**ADDENDUM NO. 2**

**PROJECT NO. 53-16-03**

**REPAIRS AND RESURFACING  
VERMILION VALLEY SERVICE PLAZA  
MILEPOST 139.50  
LORAIN COUNTY, OHIO**

**ANSWERS TO QUESTIONS RECEIVED THROUGH 12:00 P.M. MAY 18, 2016**

**FOR REFERENCE AND INFORMATION ONLY SHEET 6/8**

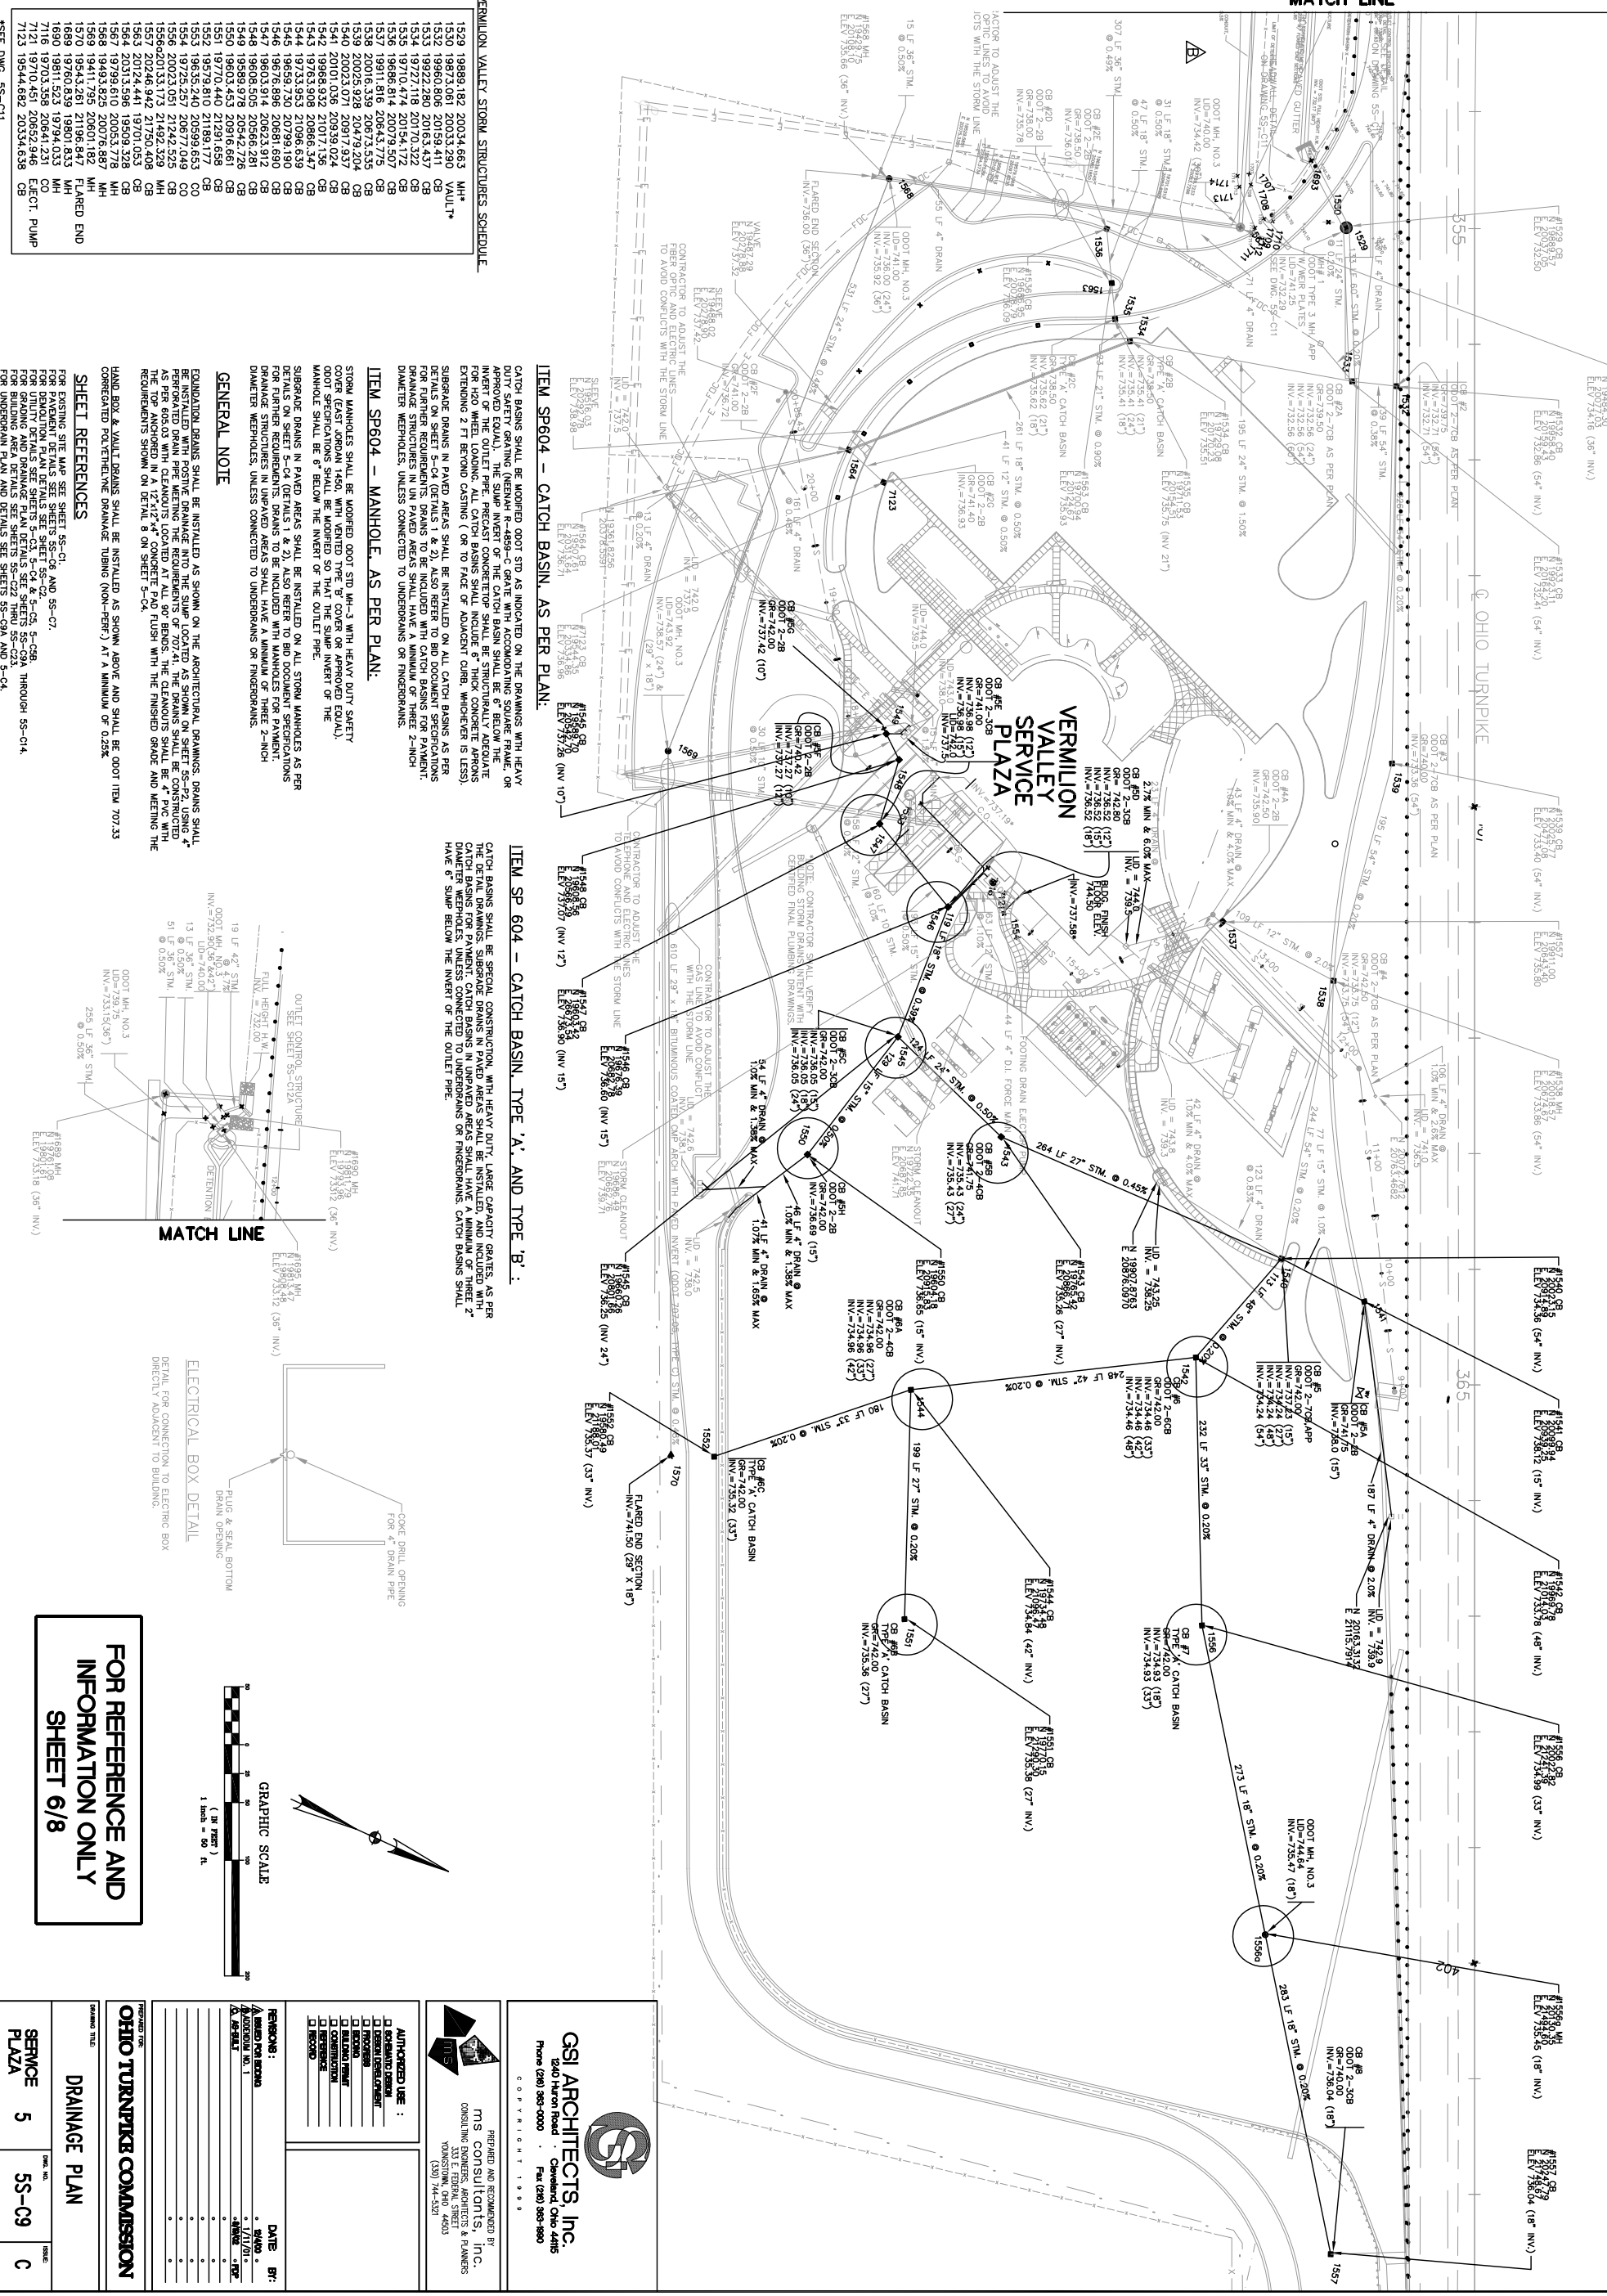
**Q#5** We are interested in the (10) item 604 items. (9) basins and (1) manhole. Am I clear that you are just wanting the tops/frames/grates replaced and not the entire structure? Also the reference plan shows roughly +/- 15 basins that are in bold. Which (9) of these need the tops replaced or modified

*A#5 As indicated in the Note on Plan Sheet 3 of 8, the Contractor is to provide a replacement grate, frame, and concrete top. The Contractor is not required to reconstruct the entire structure. For additional clarity, the manhole and catch basins that are referenced for this Project and depicted on the Reference and Information Only Drainage Plan have been circled on a Revised Plan Sheet 6 of 8. The revised Reference and Information Only Sheet is provided with this Addendum and substituted for the Plan Sheet 6 of 8 originally furnished with the Contract Documents.*
